Amendment to approved Plan C (ii)

Planning Committee 27 March 2008

University S 73 application 08/00005/OUT

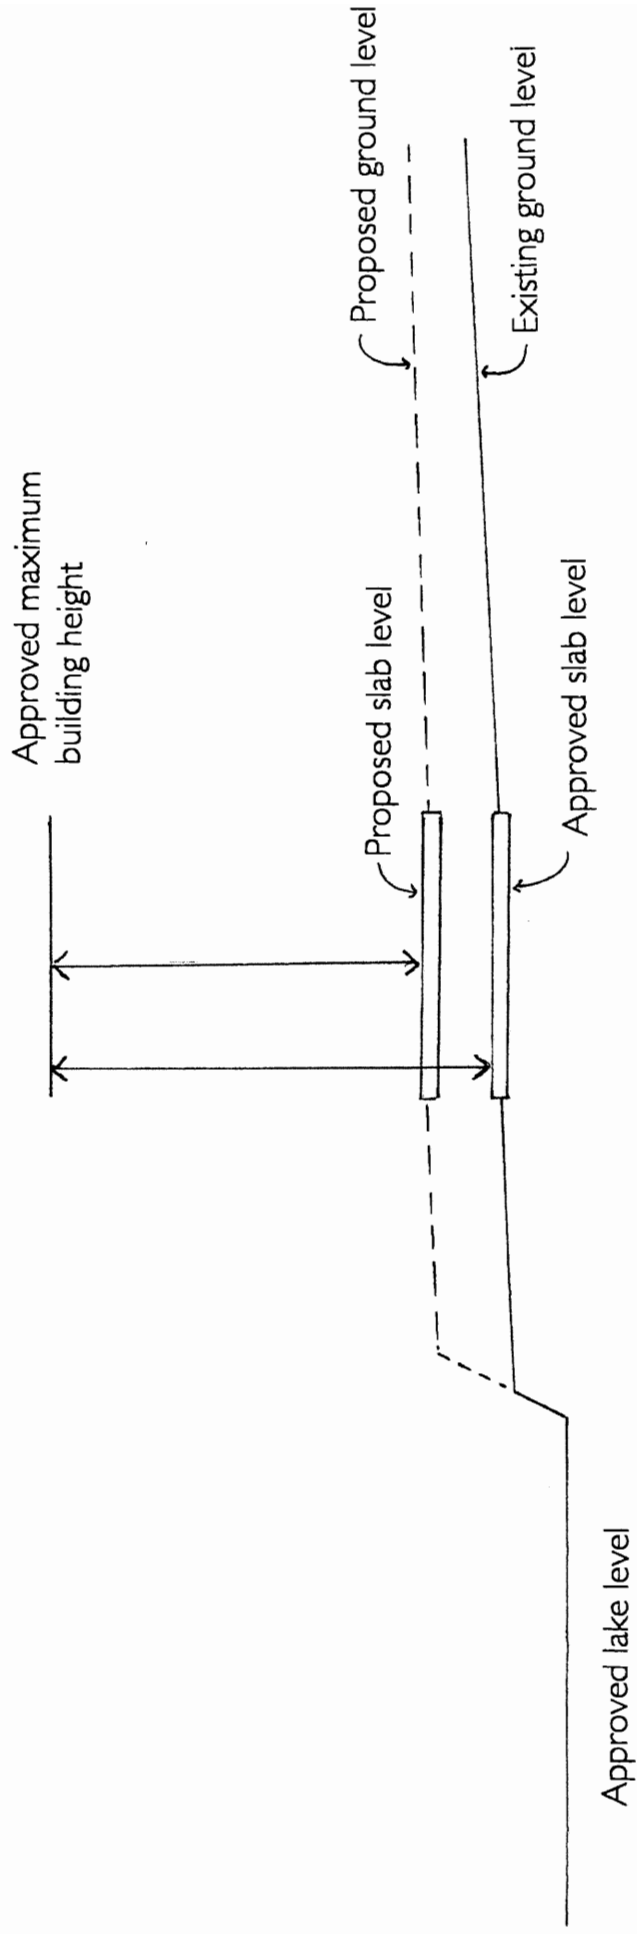
Zone	Original Max Building Slab height (AOD) (metres)	Proposed Max Building Slab height (AOD) (metres)	Difference between original and proposed (metres)
A	12.973	13.750	+ 0.777
B	15.470	15.470	No Change
C	10.883	12.500	+ 1.617
D	11.149	12.500	+ 1.351
E	10.369	12.500	+ 2.131
F	19.871	19.871	No Change
G	11.196	12.500	+ 1.304
H	20.279	20.279	No Change
I	10.850	12.500	+ 1.65
J	10.538	12.500	+ 1.962
K	20.242	20.242	No Change
L	10.880	20.242	+ 2.07
M	10.152	12.500	+ 2.348
N	18.584	18.584	No Change
O	13.194	13.450	+ 0.256
